**From:** Bailey, Heather  
**Sent:** Tuesday, May 2, 2023 4:10 PM  
**To:** 'Stu Levitan'  
**Cc:** Figueroa Cole, Yannette; Rich Arnesen; jon.furlow@gmail.com; bsfurlow71@gmail.com; Kevin Pomeroy; Stouder, Heather  
**Subject:** RE: 3701 Council Crestt

Re: *Objection to New Home Construction Application for 3701 Council Crest*  
City Legislative File I.D. No. 77464

City Legislative File I.D. No. 77464  
New Home Application for 3701 Council Crest

Photographic Diagram of Lot 2 Drainage System

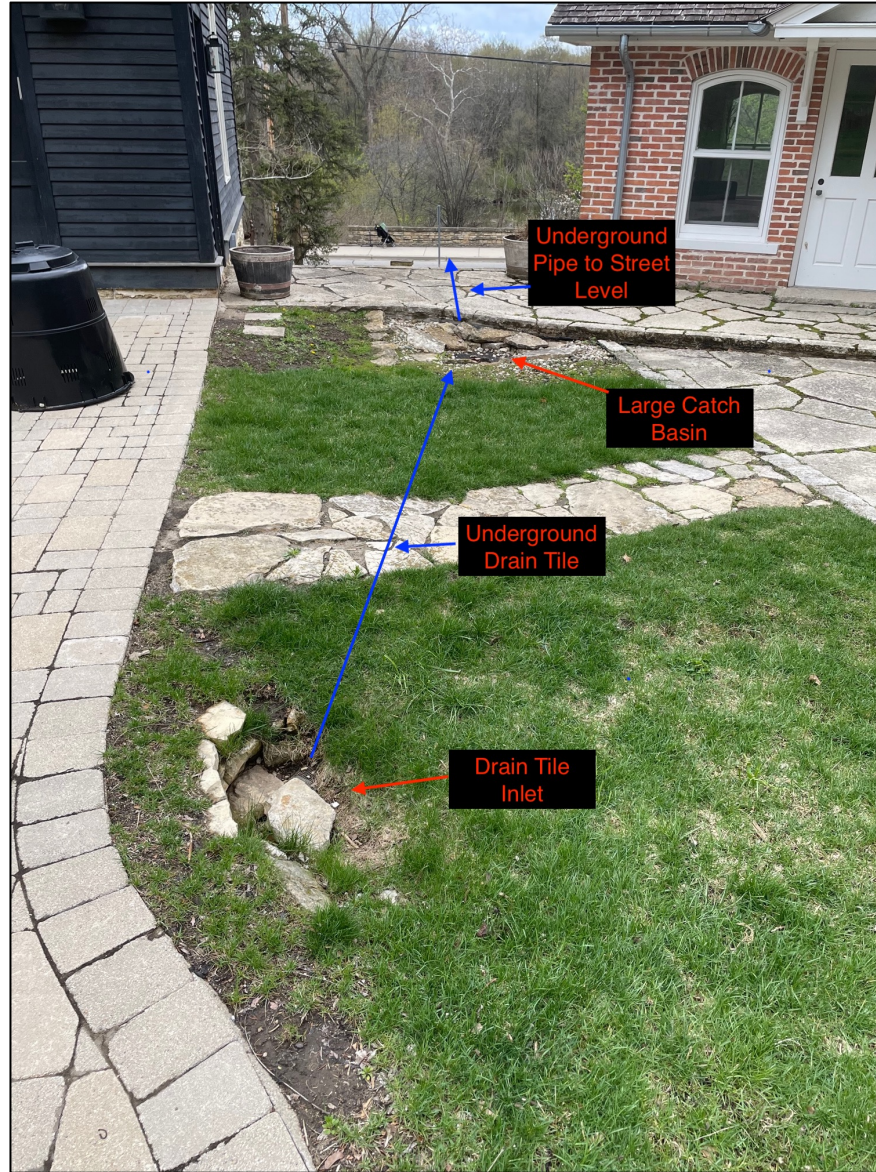
Based on our examination of the property and landscaping plans left behind by the prior owners, the existing drainage plan appears to consist of three primary components, all of which are depicted in Attachment A to this letter:

First, the prior owners built three cascading terraced tiers (berms) into the hillside of Lot 2 to capture and re-direct runoff toward a large swale. The swale channels the water away from the Tavern to the southwest corner of the property where it runs down to street level. *See Attachment A, Pg. 1* (berm drainage is marked in green, swale drainage is marked in red); *Pg. 3* (swale’s route to street level).

Second, the prior owners installed a drainage canal that spans the length of the Tavern to catch runoff not already directed toward the swale by the berms. *See Attachment A, Pg. 1* (drainage canal and runoff it captures are marked in blue).

In sum, the Commission should deny the pending application because it fails to protect the Tavern from potential damage due to drainage. The Tavern's prior owners installed an extensive drainage system that has protected the Tavern for many years. The Commission should subject any change to the existing system on Lot 2 to exacting scrutiny. At minimum, the application should include a grading plan, a runoff analysis, and a detailed report showing how the proposed landscaping, grading, and construction on Lot 2 will affect the flow of water

onto Lot 1. The Commission should also require any proposed construction to drain the front half of the property toward Council Crest and to direct water away from the Tavern toward the existing swale.
